Design Review Committee

Case 21123 – 5504 Spring Garden Road

Carl Purvis – Planning Applications Program Manager
May 11, 2017

#1 - Altered Street Façade Design & Cladding

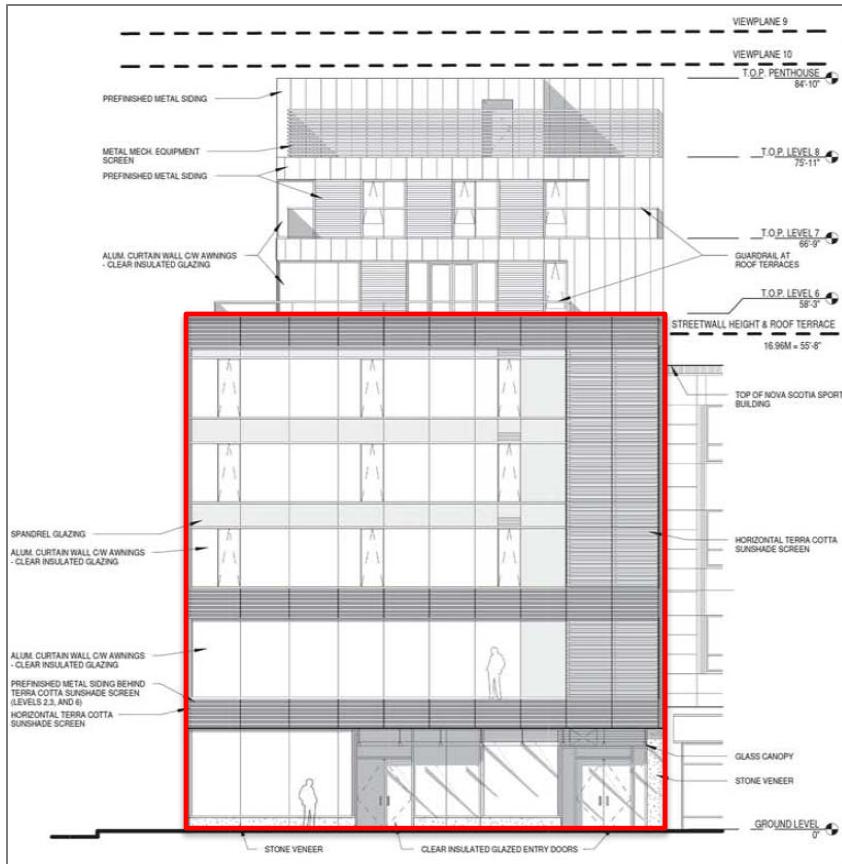
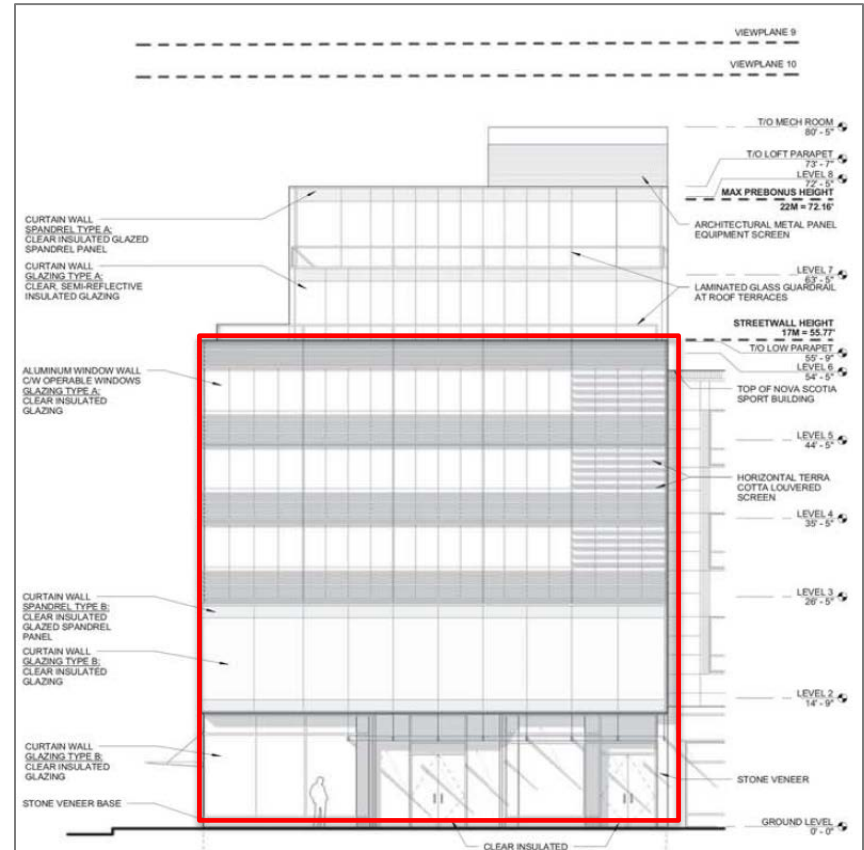
Revised design of facades on floors 1 through 5 is felt to meet the Design Manual

#1 - Altered Street Façade Design & Cladding

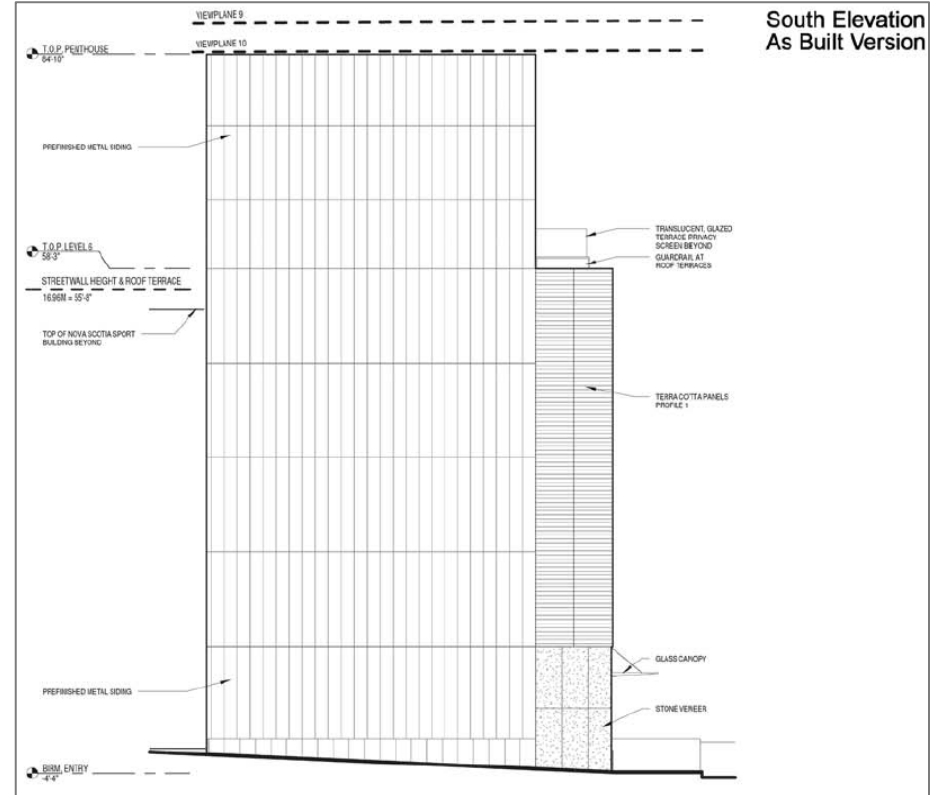
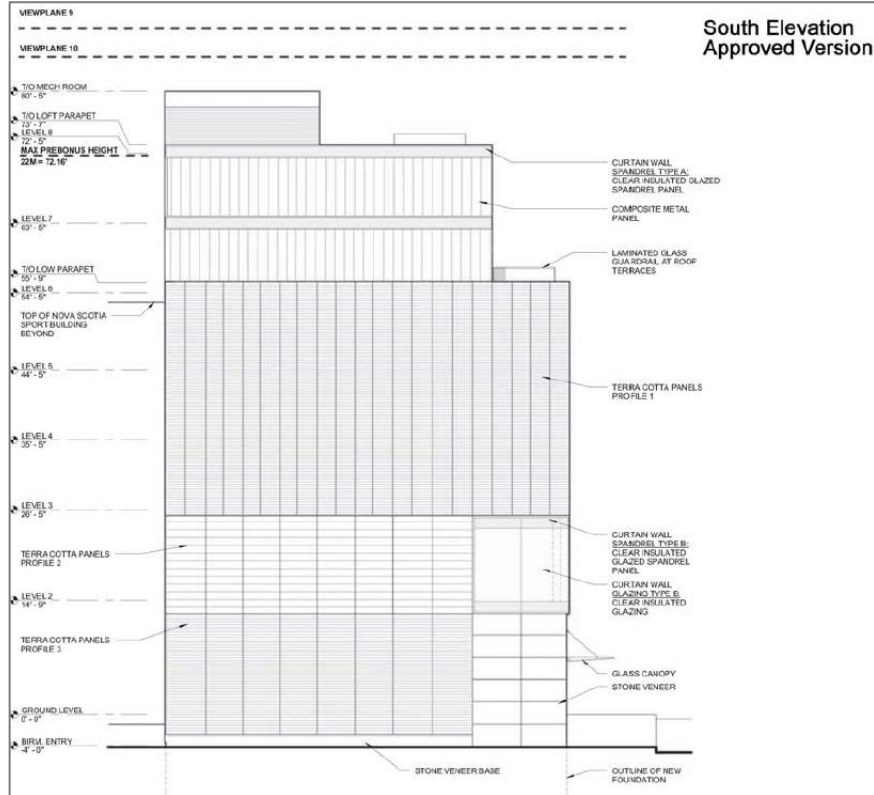
Revised design of facades on floors 1 through 5 is felt to meet the Design Manual

#1 - Altered Street Façade Design & Cladding

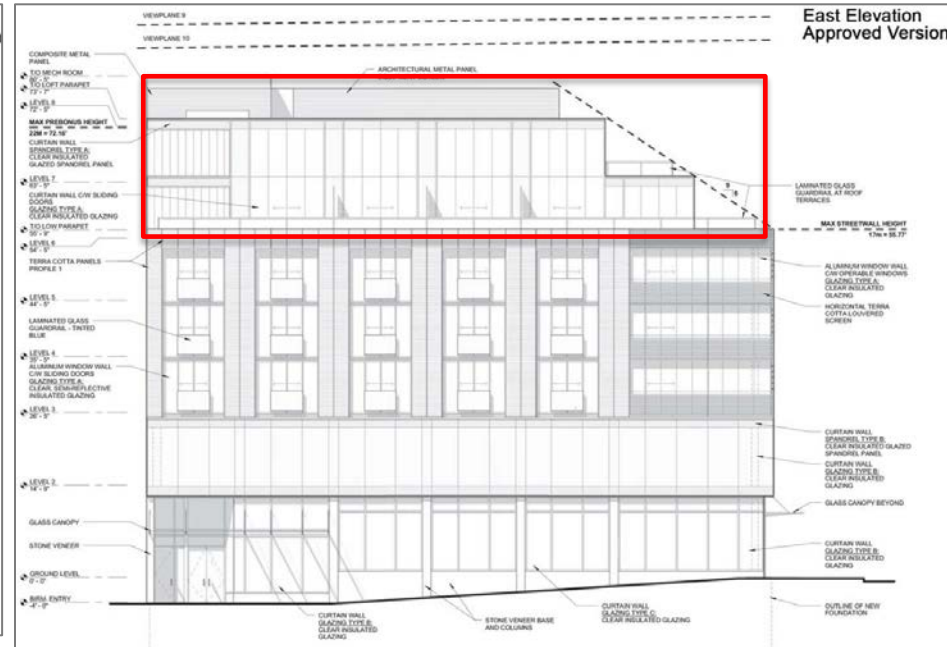
Cladding of penthouse levels along Birmingham Street and Spring Garden Road should be completed with curtain wall and spandrel panels as per Section 3.4.2 of the Design Manual.

#2 - Increase to the Size of the Mechanical Penthouse

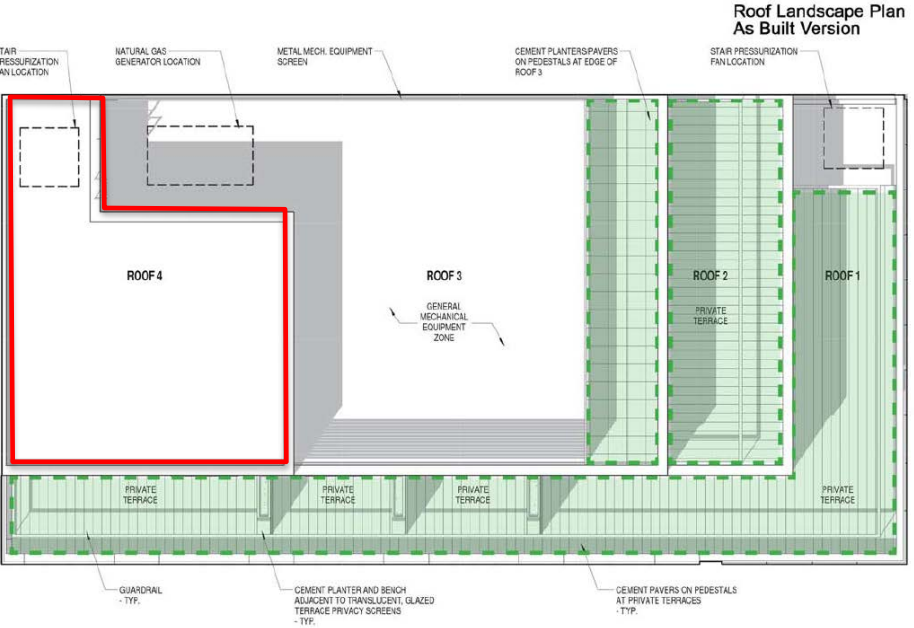
The mechanical penthouse was increased from 37 square metres to 101.5 square metres in size and located with zero setback from the side and rear property lines rather than the required 3 metres

A variance is required for the penthouse 0 metre setback from rear and side property lines. DRC Must consider criteria in Section 3.6.2 of the Design Manual:

#3 – Change to the Design of the Penthouse Railings

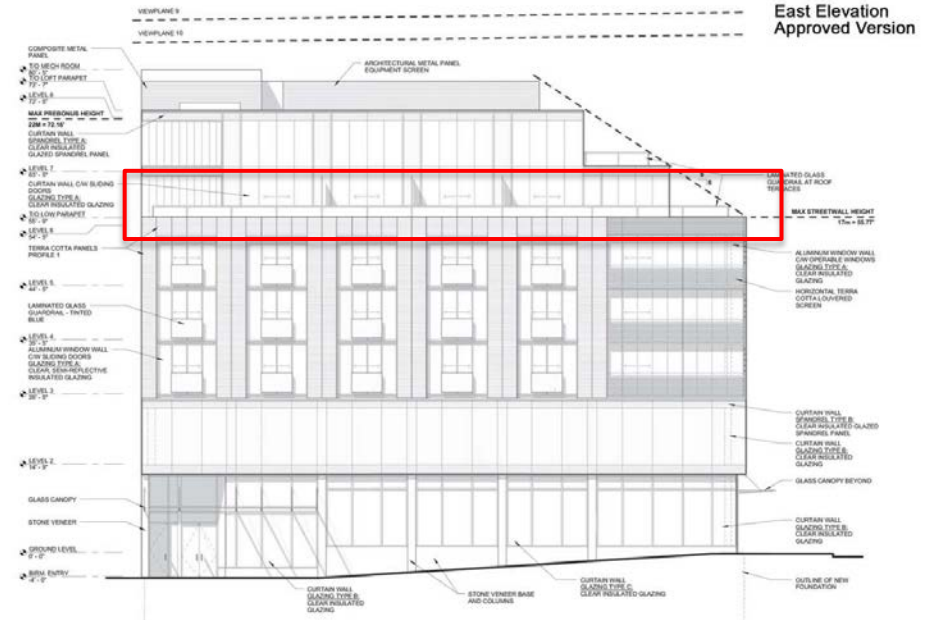
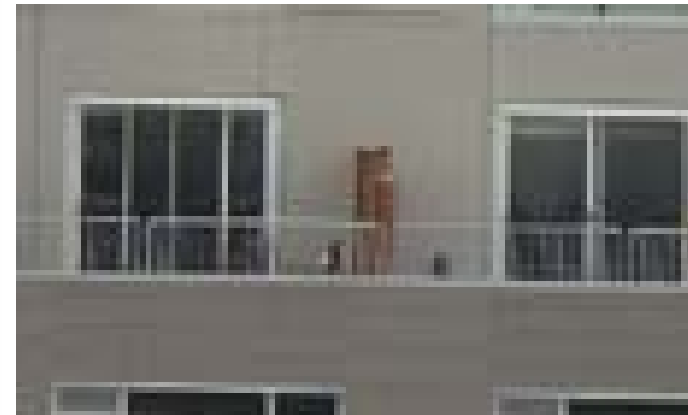
Constructed as steel frame and balusters

Original approved as glass panels
